APPENDED FIELD SAMPLING PLAN FOR TASK ORDER 1

**RCRA Facility Investigation/Corrective Measures
Study (RFI/CMS) and Base Closure Environmental
Study for the Lexington-Blue Grass Army Depot**

USEPA review comments of July 31, 1991, on the original document were incorporated into this appendix unless the comment suggested work outside the contracted scope of work for Task Order 4. Work outside the contracted scope will be conducted at a later date, as deemed necessary by the COR.

AMENDMENTS/CLARIFICATIONS/ADDITIONS TO THE SAP

**OLD LANDFILL AND INDUSTRIAL-SANITARY
LANDFILL SAMPLING LOCATIONS
LEXINGTON FACILITY**
LEXINGTON, KENTUCKY

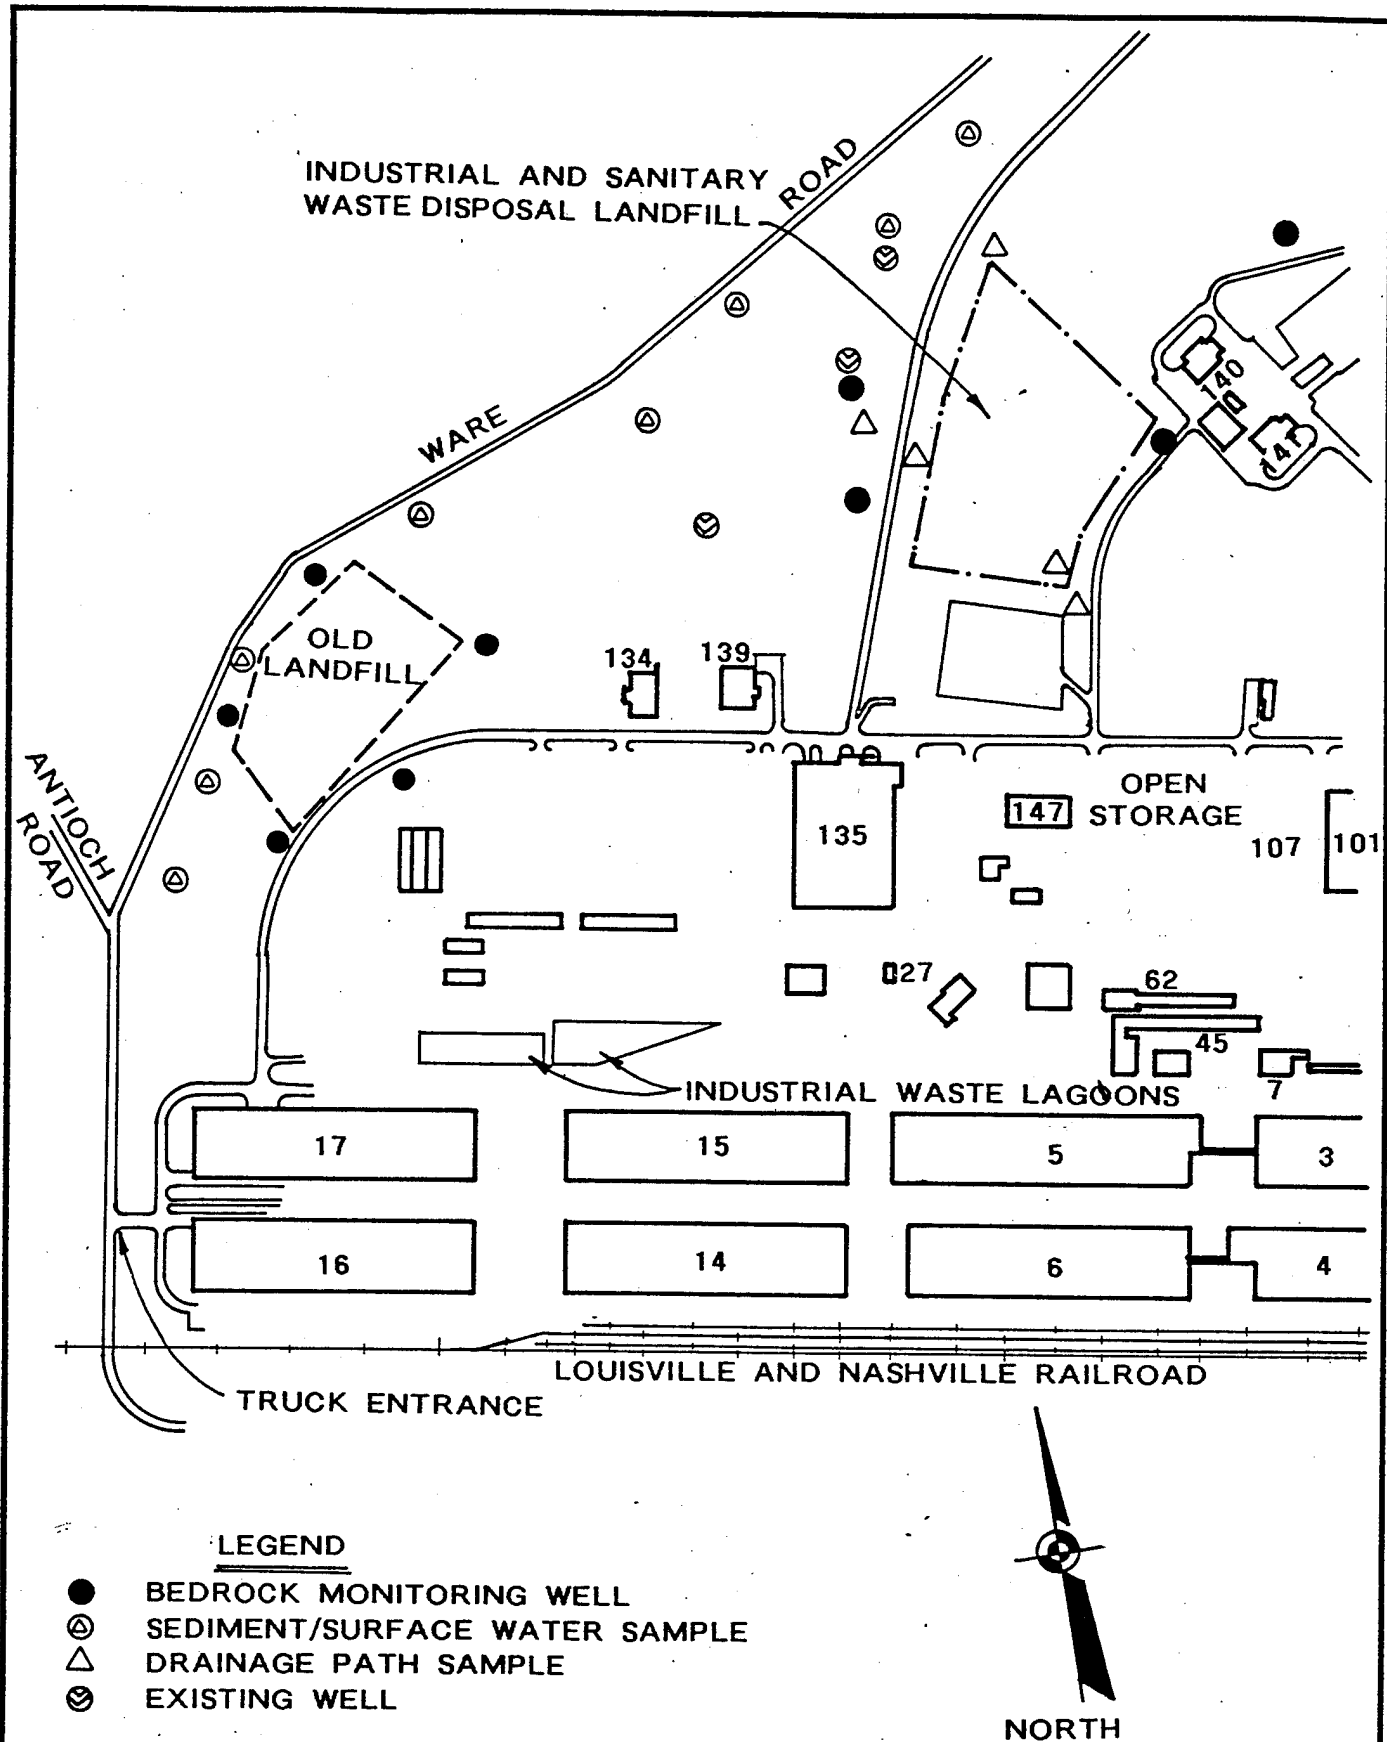
Figure 4-1 revised to show new well and sampling locations. See attached revised map.

NEW LANDFILL SAMPLING LOCATIONS
LEXINGTON FACILITY
 LEXINGTON, KENTUCKY

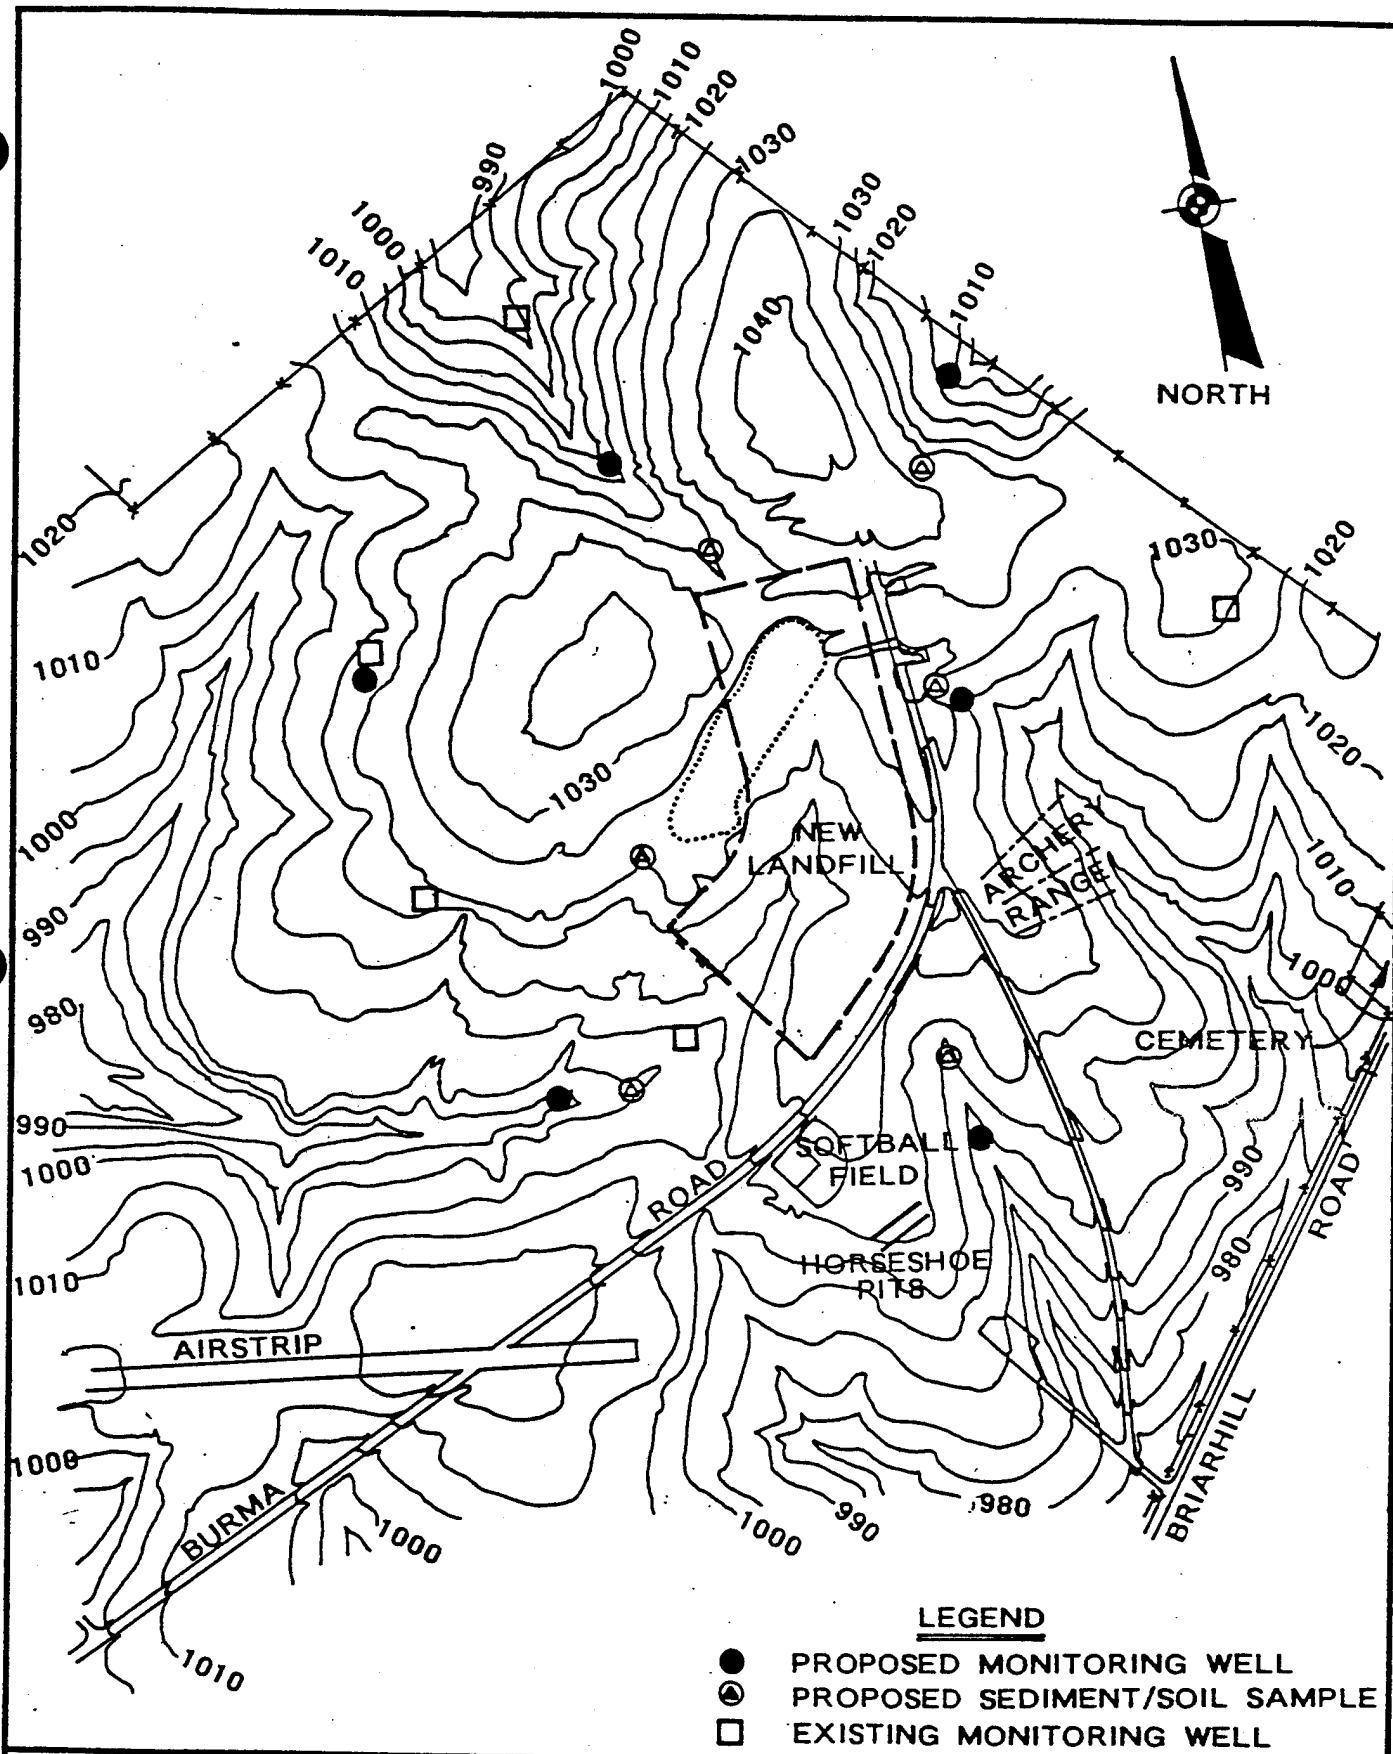
Figure 4-2 revised to show new well and sampling locations. See attached revised map.

BACKGROUND SAMPLING LOCATIONS
LEXINGTON FACILITY
LEXINGTON, KENTUCKY

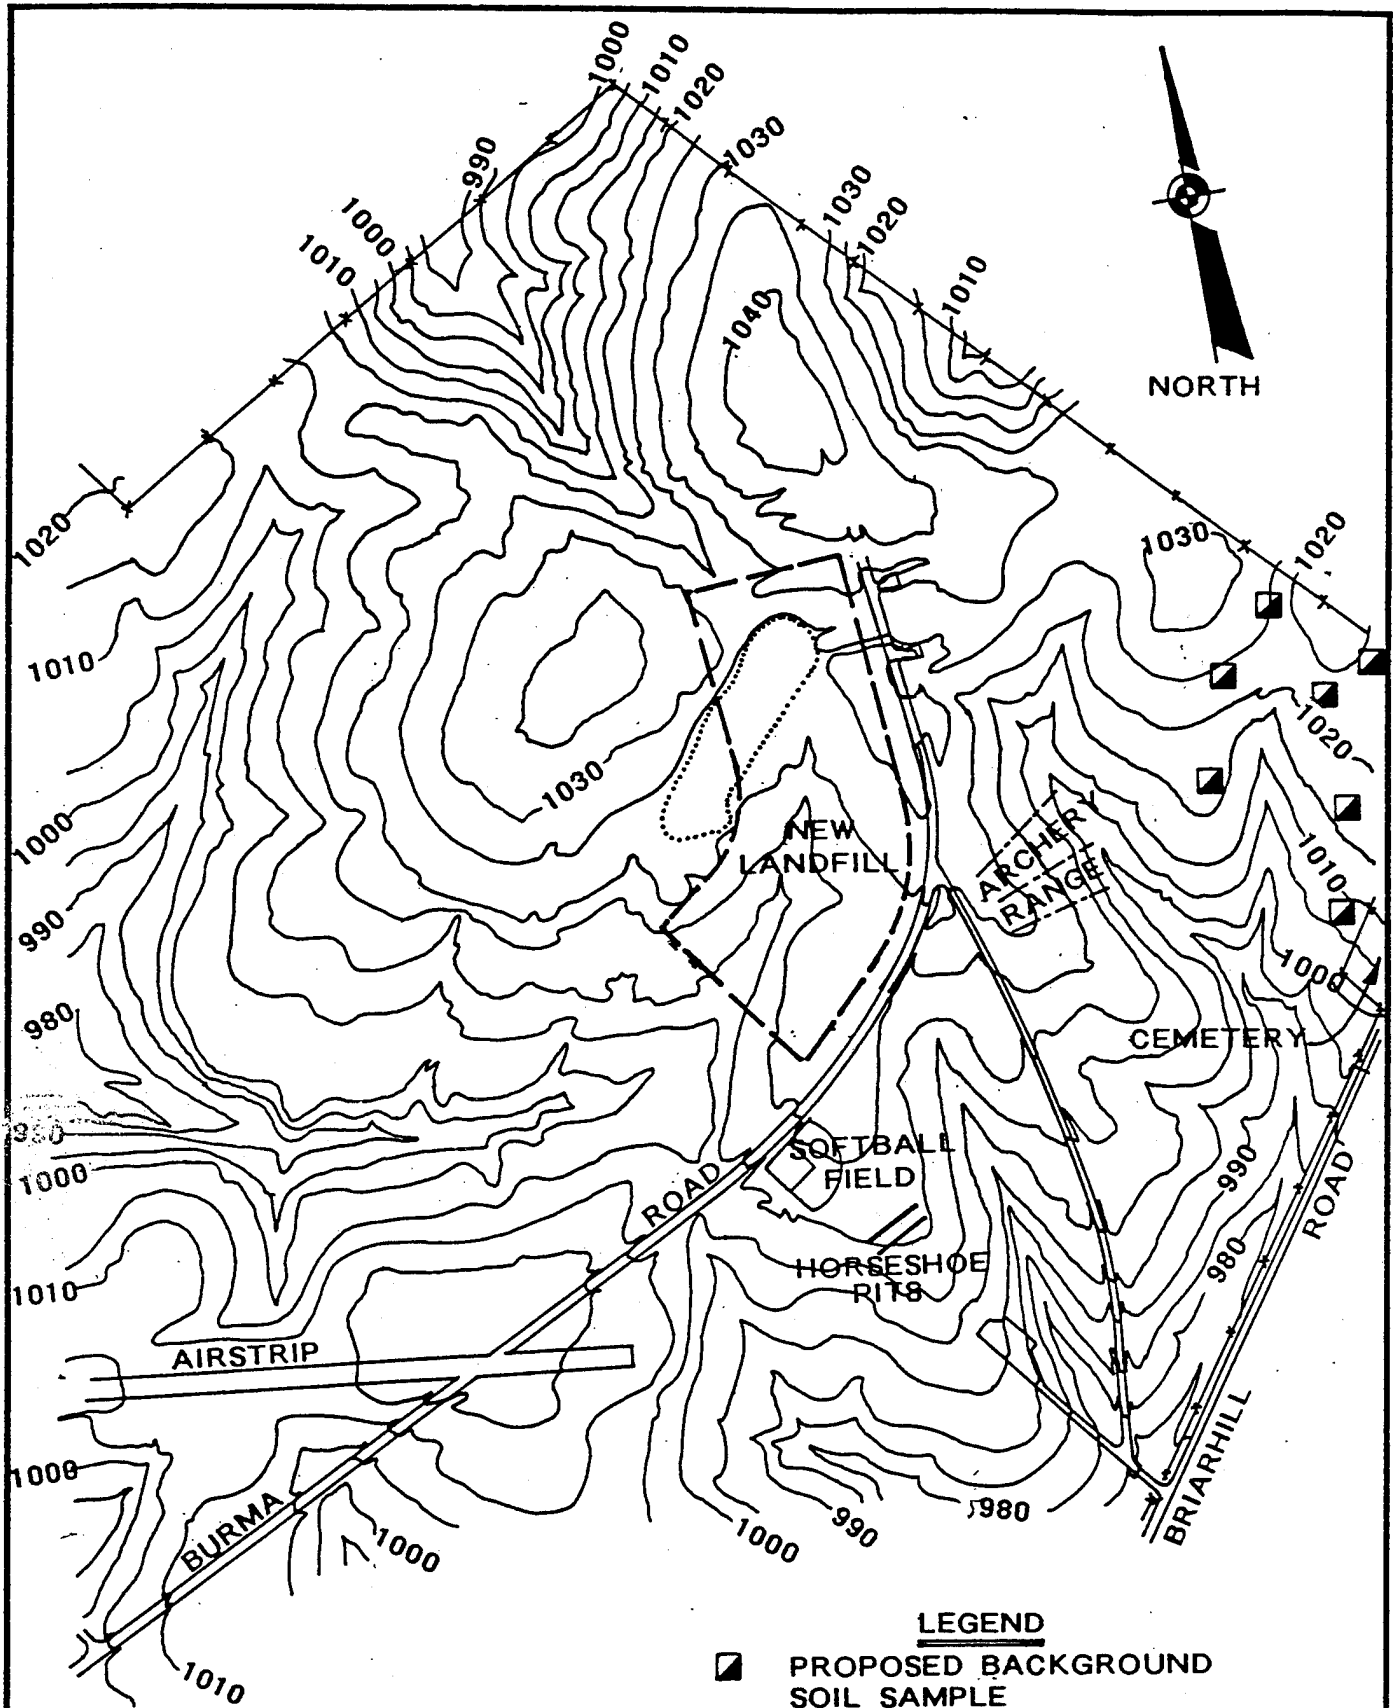
Shallow Soil Borings: Seven (7) shallow soil borings will be drilled within the area described at the locations shown on Figure 4-13. Samples will be collected in the borings at a depth from 0 to 1 foot, 2 to 3 feet or to auger refusal. These samples will be collected according to procedures described in Section 3.11, and will be analyzed for Target Compound List (TCL) compounds (except for Volatiles in the 0 to 1 foot interval.

Figure 4-13 added to show new background sampling locations. See attached map.
